Subject: 10CFR21 Reporting of Defects and Non-Compliance -
Engine Systems, Inc. Report No. 10CFR21-0085, Rev. 0

EMD Engine-Driven Water Pump Assemblies

Report No. 10CFR21-0085
Rev. 0: October 04, 2002

COMPONENT: Engine Water Pumps
EMD P/N 40089540, 40089541, 40089881, 40089882

FIGURE 1
Water Pump Cross Section

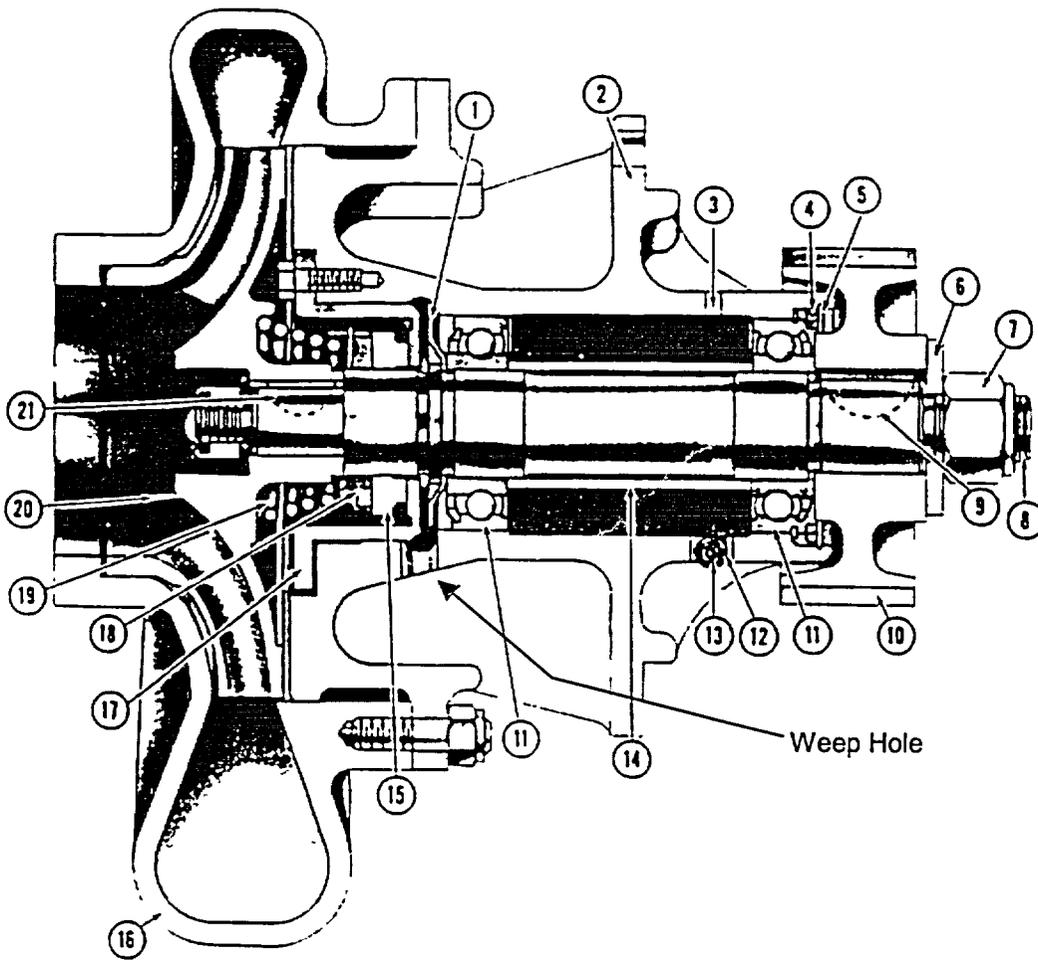
The water pump impeller and shaft assembly is supported in the housing by two roller bearing assemblies, item 11. The bearings are lubricated by splashed engine lube oil entering through the inlet hole, item 3, located in the top of the drive end of the support housing. Oil exits the bearing cavity through the oil outlet hole, item 12, located in the bottom of the drive end of the support housing. The cooling water is sealed through a mechanical seal assembly located at the impeller end of the shaft assembly, items 15, 17, 18 & 19. The cavity between the bearings and mechanical seal contains a drilled passage (weep hole) to provide an external visual indication of leakage of water from the mechanical seal as well as to prevent water from contaminating the bearings and engine oil system.

In an effort to extend the service life of the water pump assemblies, EMD redesigned the bearings, shaft and support housing to utilize tapered roller bearings in lieu of spherical roller bearings. The tapered roller bearings were mounted as opposed pairs in a back-to-back arrangement. A seal was installed at the opposite-drive end of the shaft to prevent oil leakage into the cavity and out the weep hole. This modification was incorporated on all water pumps applicable to 16 & 20 cylinder EMD engines. The earlier design pumps utilizing spherical bearings were discontinued in April, 2000.

Through the locomotive and marine industry, EMD has found that the redesigned pumps are experiencing premature failures of the internal seals resulting in leakage via the weep hole. The primary leaking fluid is engine cooling water, however, leakage of lubricating oil from the bearing side is a possibility. The seals are failing as a result of an insufficient preload on the tapered roller bearings. Without adequate preload, there exists excessive clearance between the rollers and race. This clearance results in chattering of the rolling elements and relative movement of the shaft within the pump. The issue applies to the design of the pump assembly relating to establishing and maintaining adequate preload on the bearings during operation. The problem is not a result of incorrect assembly.

No method is available to indicate the condition of the seals within the water pump assembly. The service history of the pumps with tapered bearings has indicated the seal failures occur either immediately or prematurely after a low number of operating hours. It is for this reason that it is recommended to replace the tapered bearing pumps with the previous design units using standard roller bearings.

Replace the tapered roller bearing water pump assemblies with standard roller bearing water pumps as identified below. Use the leakage rate (if present) as an indicator of the urgency of pump replacement. If no leakage is present, continue with monthly leak inspections and replace the pumps at the next available opportunity.
